**A RESOLUTION OF THE CITY OF GRAND PRAIRIE, TEXAS,  
APPROVING THE CITY OF GRAND PRAIRIE'S CITY-WIDE  
DRAINAGE MASTER PLAN FOR CEDAR CREEK.**

# City of Grand Prairie City-wide Drainage Master Plan for Cedar Creek (Y#0845)

**AECOM TECHNICAL SERVICES, INC.  
16000 Dallas Parkway  
Suite 350  
Dallas, Texas 75248  
TBPE Reg. No. F-3580**

**August 2011**

Figure VI-1

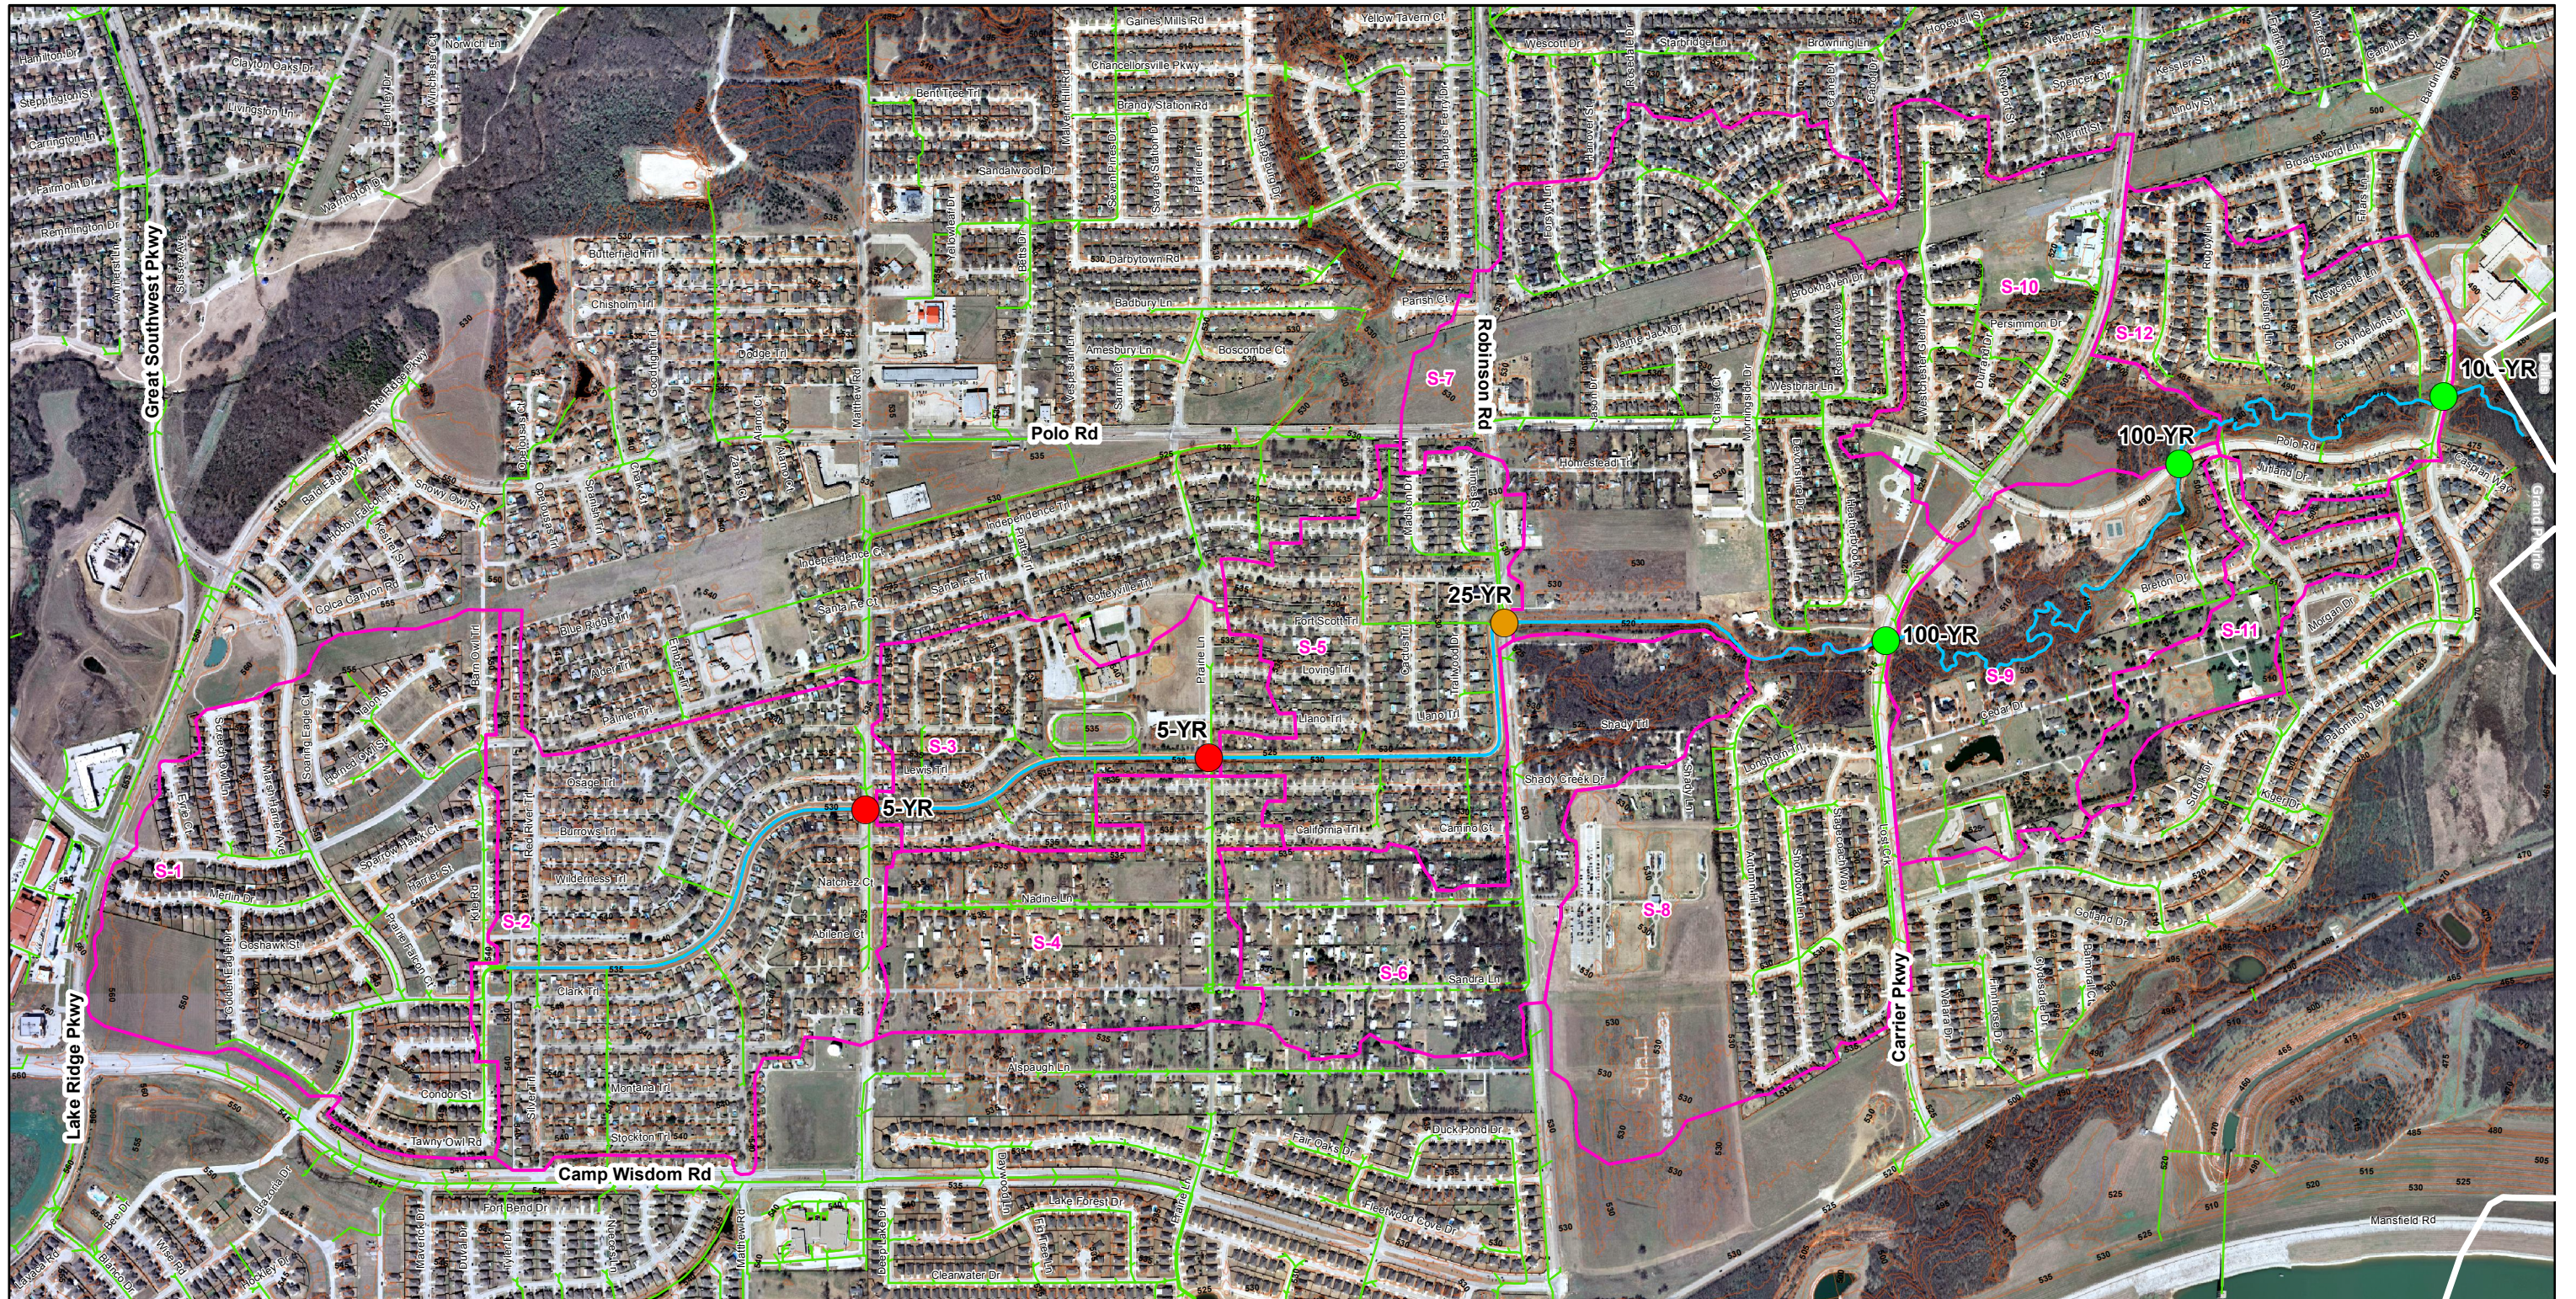
12. *Section VI – Include a map that shows the roadway crossings and denotes what frequency the roads will pass. Use figure VI-1 from the Joe Pool DMP as a go-by*

**Response:** AECOM has added Figure VI-1 Roadway Crossings to the Cedar Creek Drainage Master Plan report.

CITY-WIDE DRAINAGE MASTER PLAN FOR CEDAR CREEK (Y#0845)		
TOPOGRAPHIC WORK MAP (ROBINSON ROAD TO BARDIN ROAD)		
		AECOM TECHNICAL SERVICES, INC. 16000 DALLAS PARKWAY, SUITE 350 DALLAS, TEXAS 75248 WWW.AECOM.COM TBPE REG. NO. F-3580
DATE: 08/11	PROJECT NO.: 60185331	Figure 6a

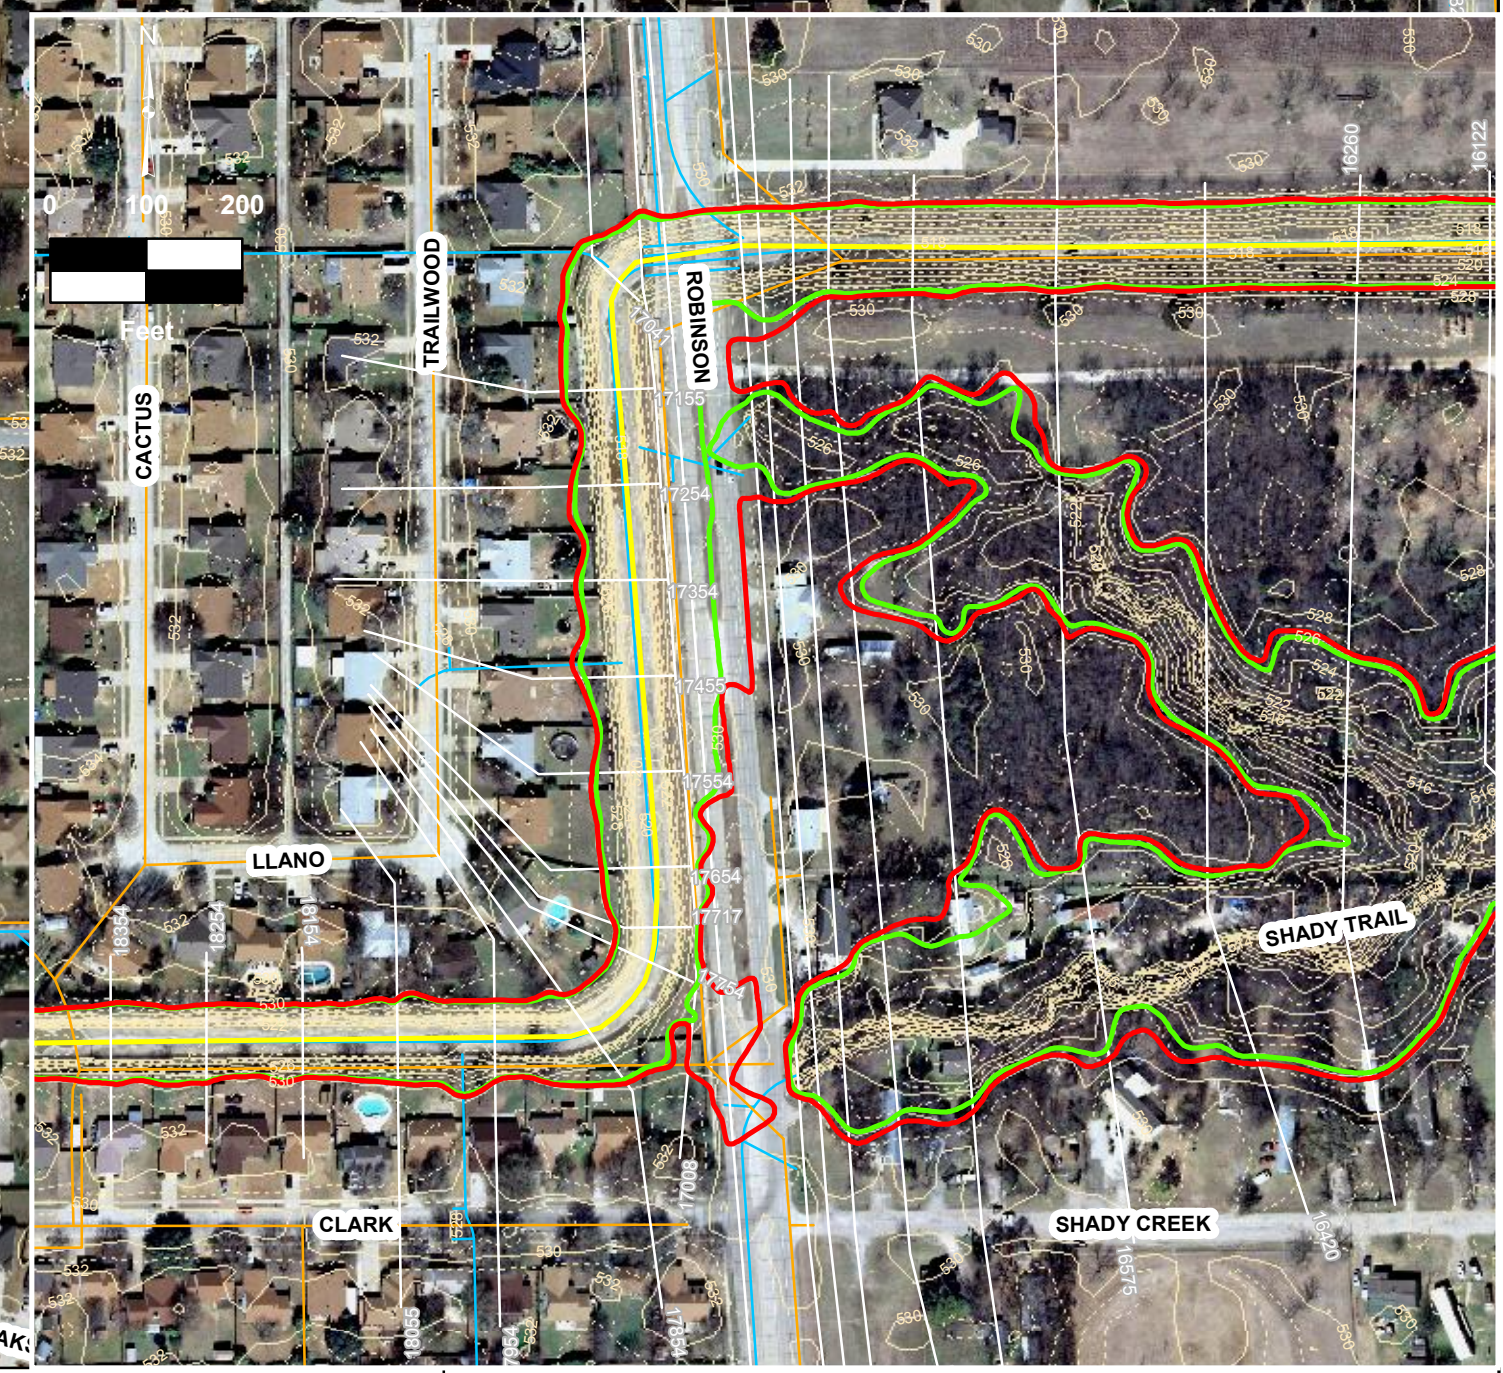
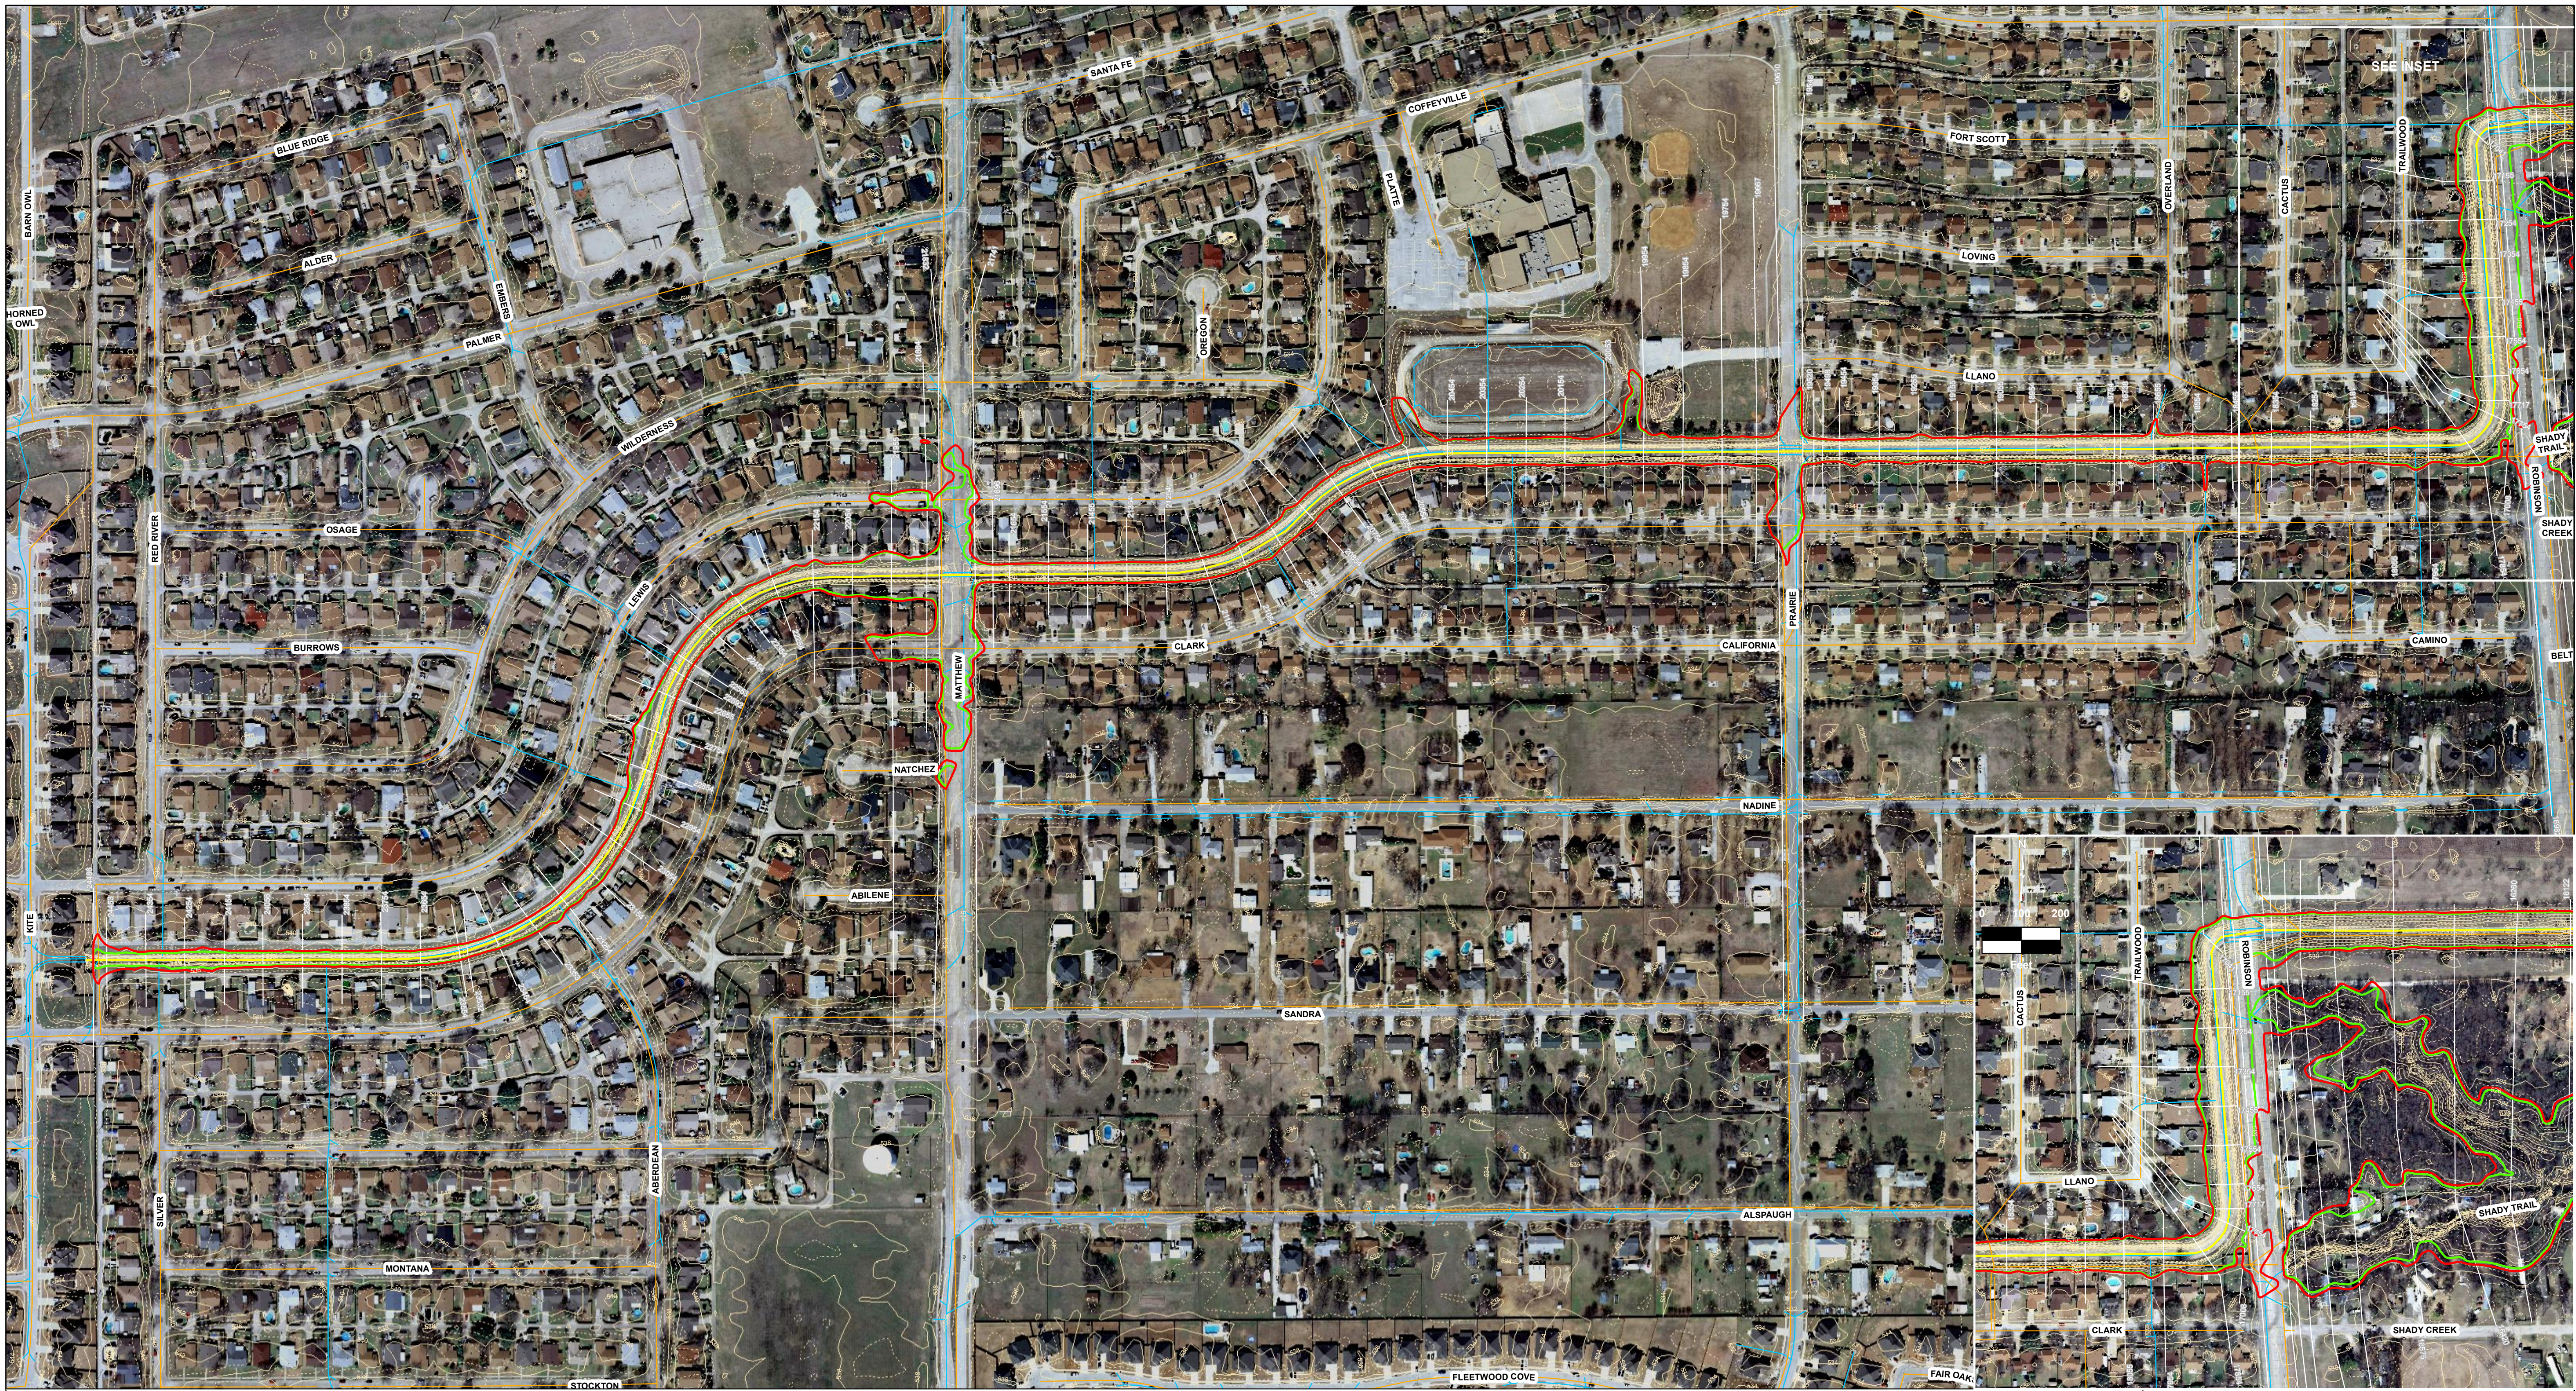
8. *Section III-A – Add the location of the lateral weir to Figure 6a and add a note to the figure stating, “The lateral weir was modeled as described in Section III-A of the Cedar Creek Drainage Master Plan.”*

**Response:** AECOM has updated Figure 6a as per the City’s request.
